Staff Report for Item 2

Application Number: H14-01-1317

Address: #1309 Newton Street

Second Reading: Partial demolition of rear addition and demolition of rear roof.

1892 Sanborn Map

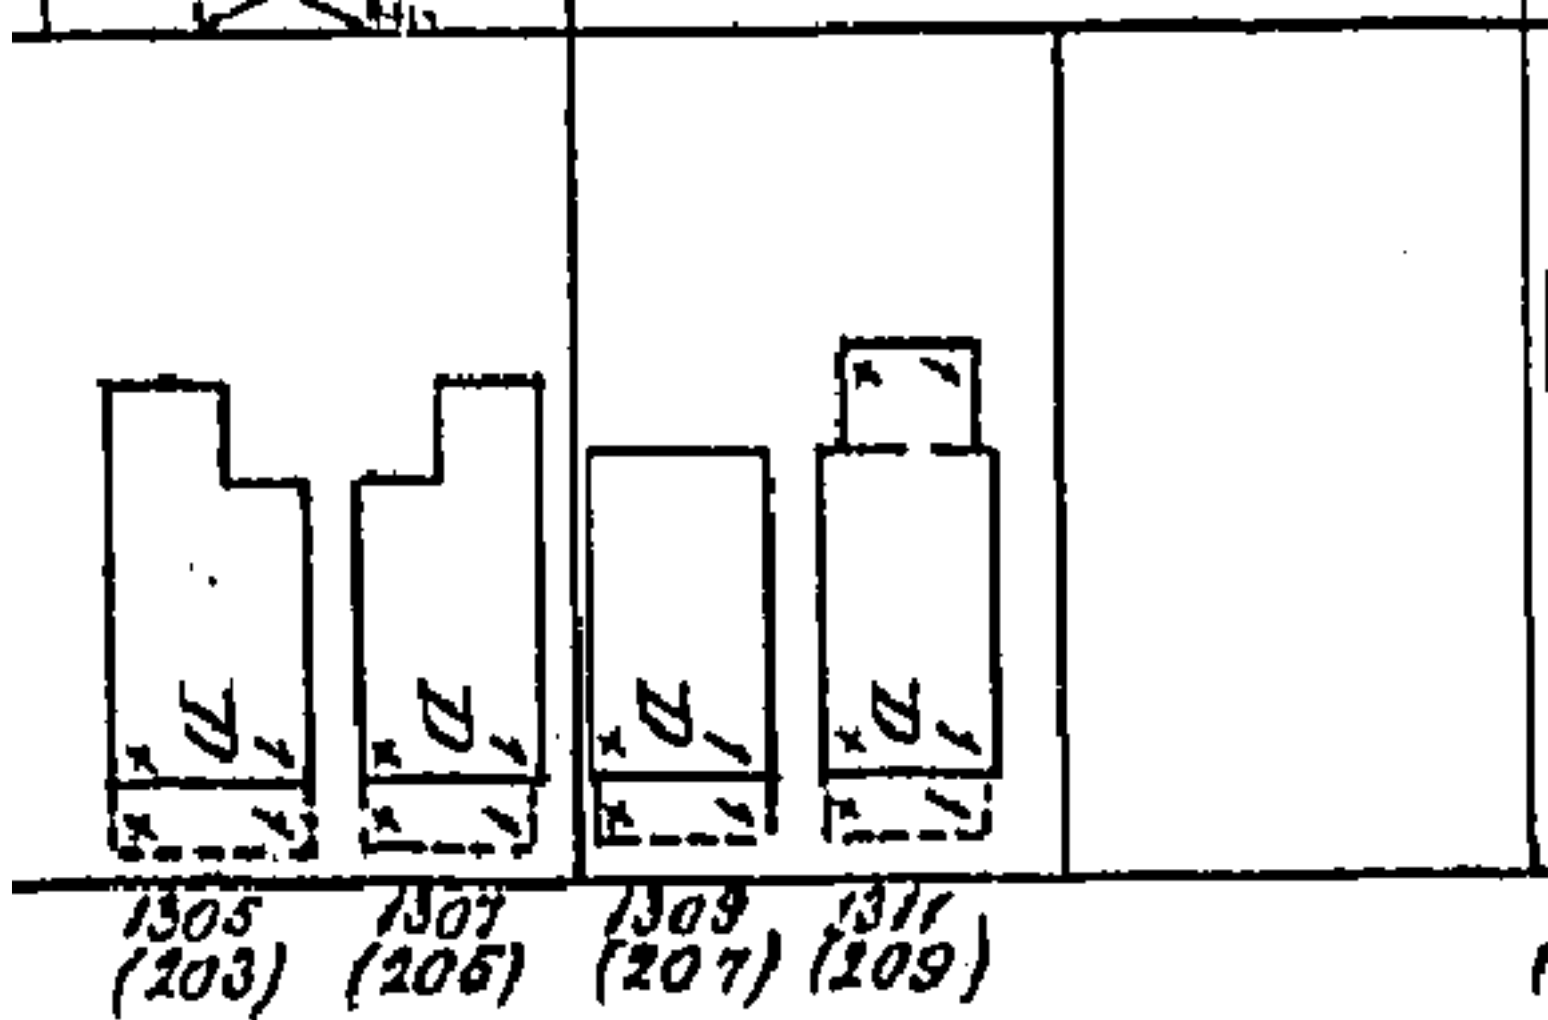
The roof in question is part of an addition closest to the main house, which might be original to the house. The 1892 Sanborn map shows a rear addition. While that addition is not depicted formally again on the Sanborn maps, there is an addition of a similar size in a 1964 aerial photograph. Also, that addition has the same asbestos siding as the main house, where as the other additions have novelty siding. This gives credence that the additions were constructed at different dates, and the shed roof addition is more tied to the main house than the other rear additions. With this evidence, staff believes the rear addition closest to the main house is historic.

2 DEMOLITION PLAN
1/4" = 1'-0"

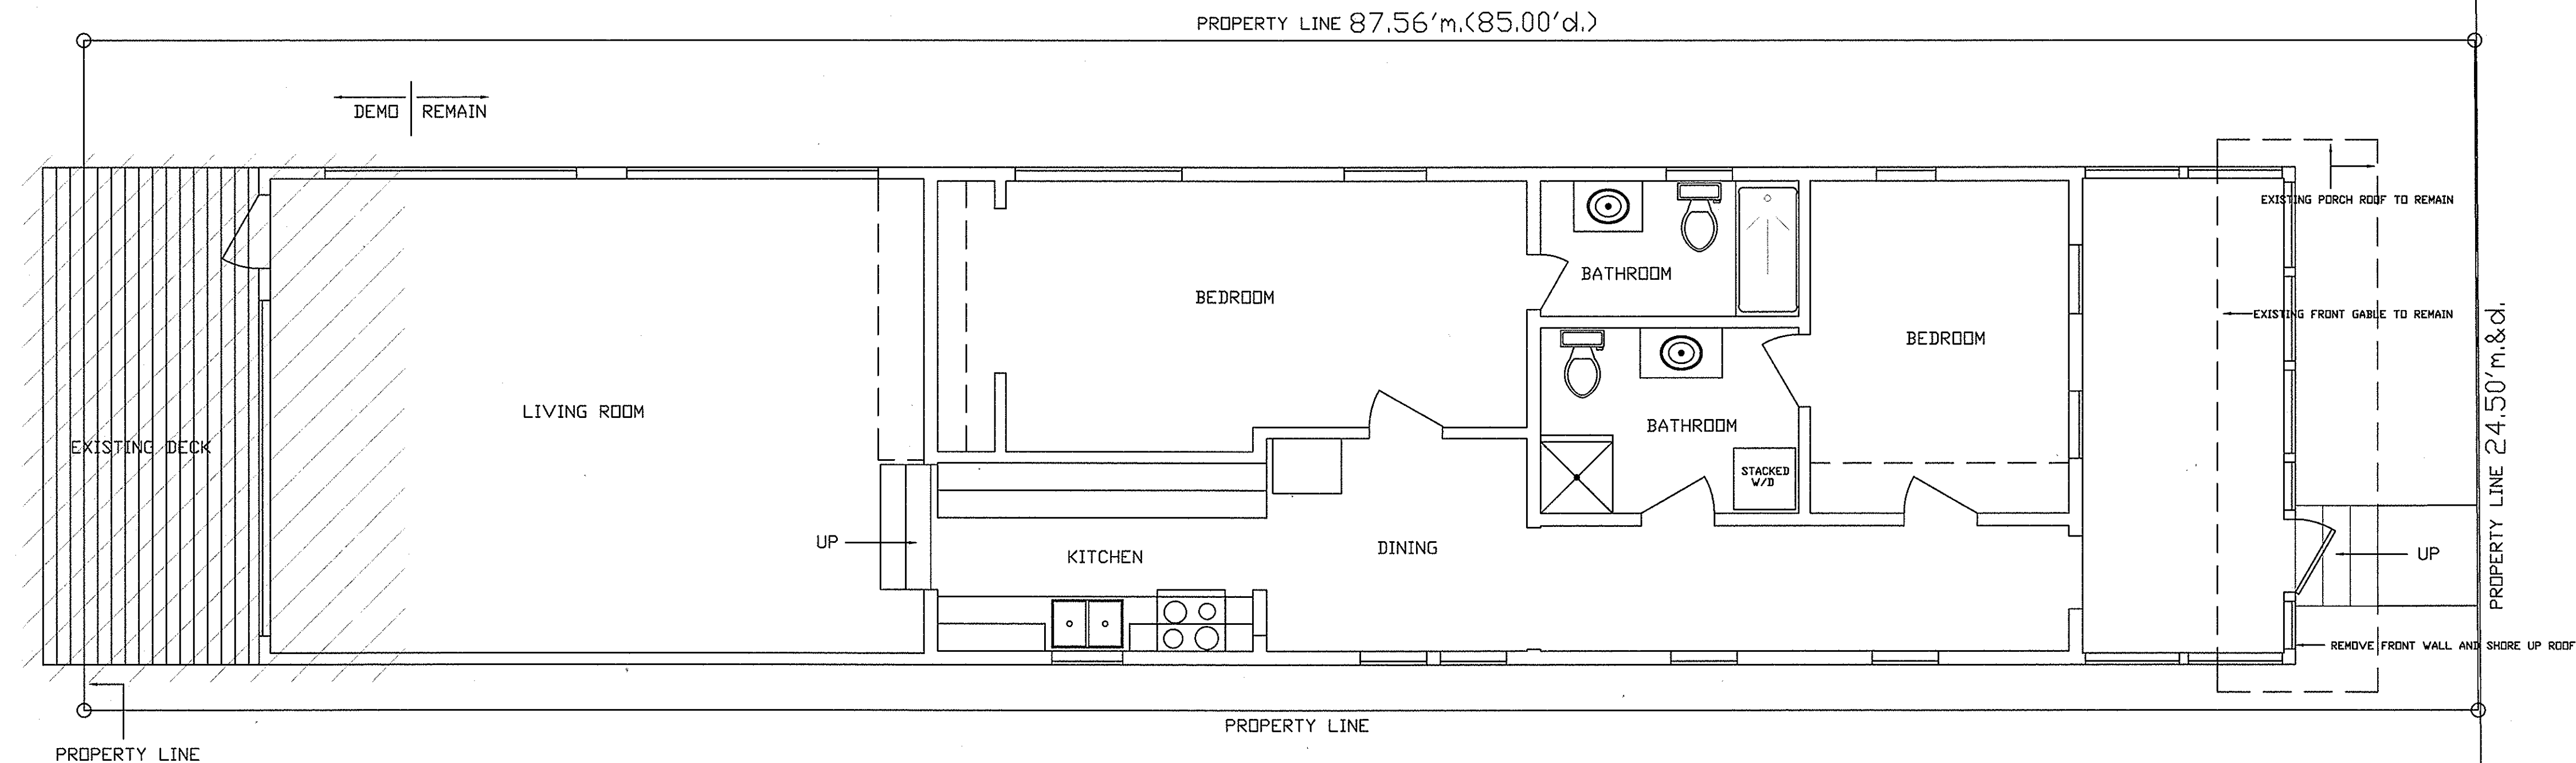
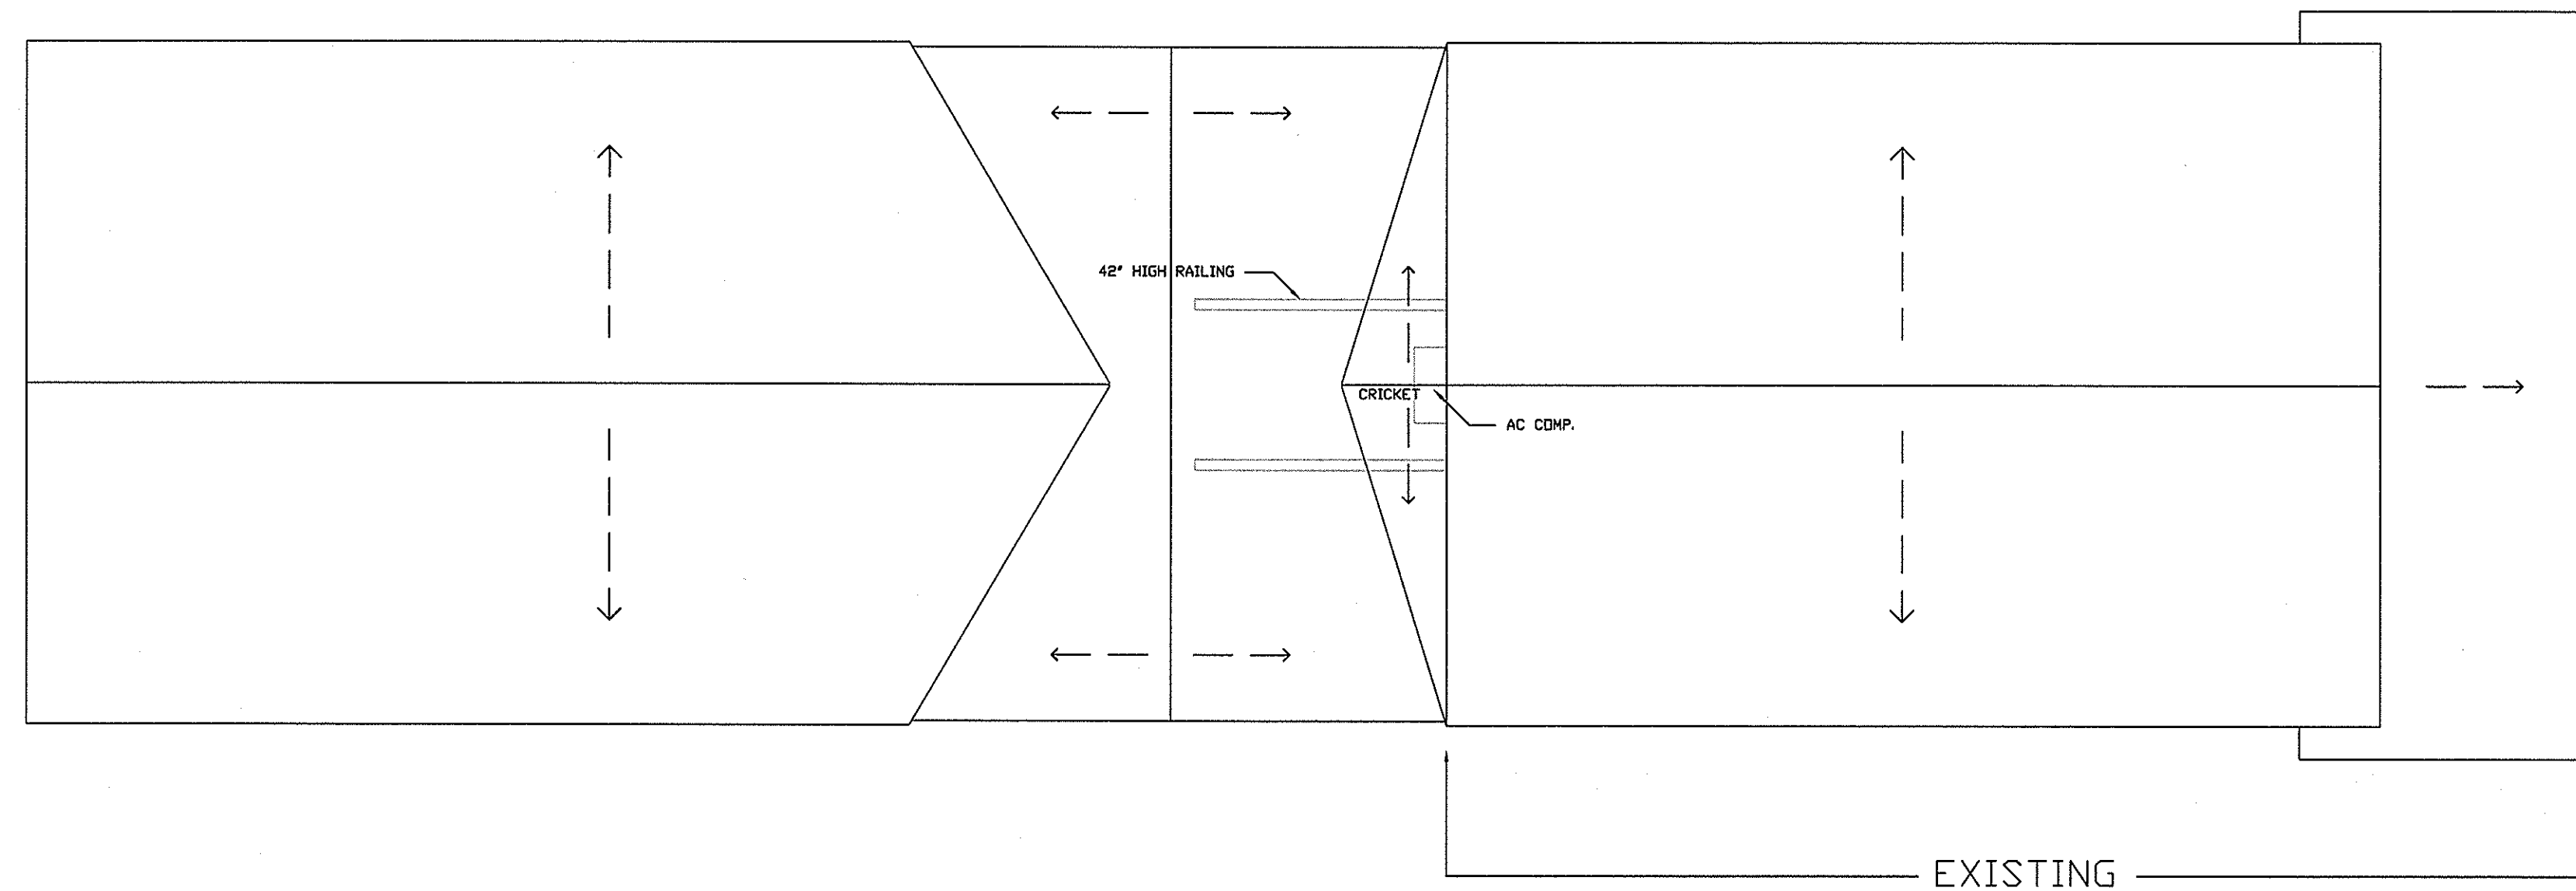
This is the second reading for a Certificate of Appropriateness proposing demolition of a roof of a historic rear addition. The Commission approved the first reading of demolition on February 24, 2015.

Although the one shed roof structure is older than fifty years, it is not visible to the street nor is it a character defining feature of the property. Staff believes it does not meet any of the criteria listed in Sec. 102-125 (1) through (9) and that the shed roof will be deemed contributing in the near future; thus, the Commission should consider the demolition request. If approved, this will be the final reading for demolition of the roof of the shed roof addition closest to the main house.
